1 INTRODUCTION

- 1.1.1 This Technical Note (TN) provides a formal highways response by Prime Transport Planning (Prime) in relation to application reference 25/00458/FUL for the redevelopment of the former Huyton Cricket Club site, Huyton Lane, Knowsley, comprising residential development and associated infrastructure. The application was submitted to Knowsley Metropolitan Borough Council (KMBC) by Breck Homes Ltd (hereby referred to as the 'Applicant') following a period of formal pre-application engagement with the Local Highway Authority (LHA) (Ref: 25/00016/PREAPP).

3 HIGHWAY REBUTTAL

PROPOSED SITE ACCESS FROM
B5199 HUYTON LANE ROUNDAABOUT

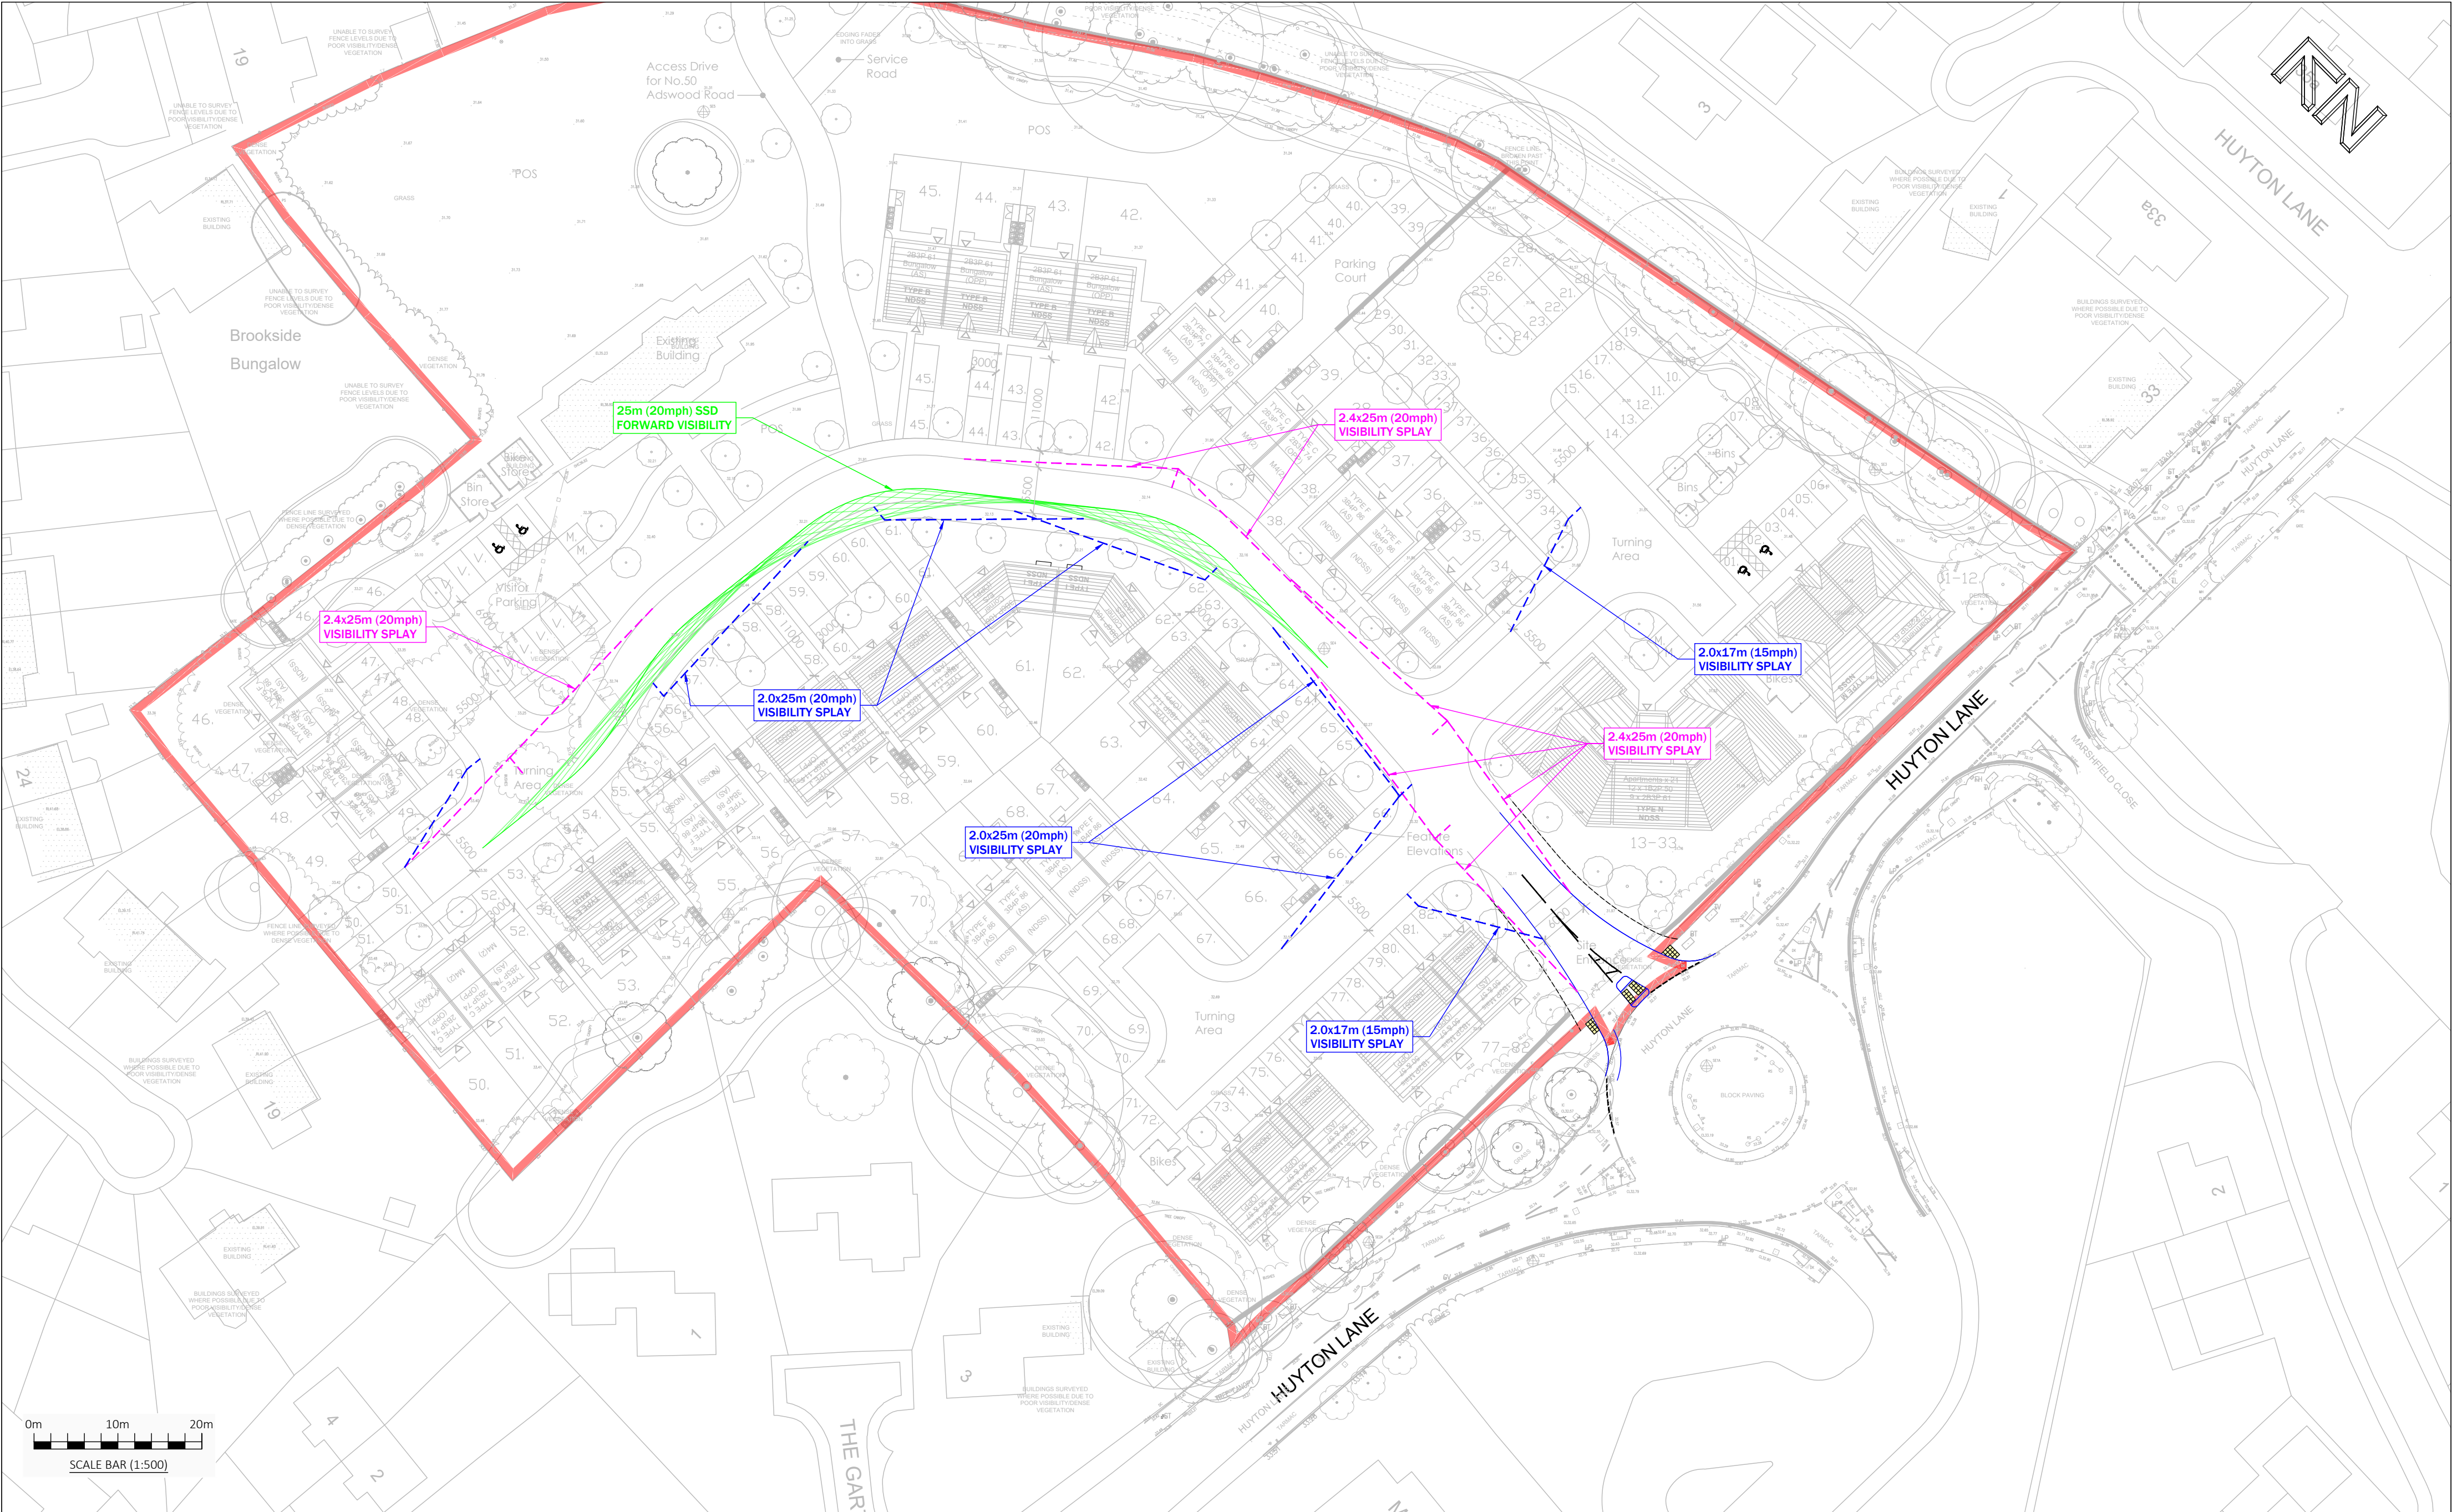
'The submitted plans do not illustrate the required visibility. The applicant must provide scaled drawings demonstrating visibility in accordance with DMRB CD116.'

'In line with Knowsley's adoptable standards for highway infrastructure, for a residential development of this scale the site access should be a minimum of 6.0m in width. The submitted plans do not confirm this and amended drawings are required.'

- 3.2.1 Please see Drawing P24120-001D in Appendix III of this TN.
- 3.2.2 Visibility for all existing roundabout arms remains unaffected.

- 3.2.3 Please see Drawing P24120-001D in Appendix III of this TN.

D	22/01/26	RO	AMENDED TO LHA COMMENT
C	02/05/25	RO	KERB RADII AMENDED
B	08/02/25	RO	UPDATED TO TOPO SURVEY
A	09/01/25	RO	ROUNDAABOUT GEOMETRY UPDATED
Rev	Date	By	Revision notes
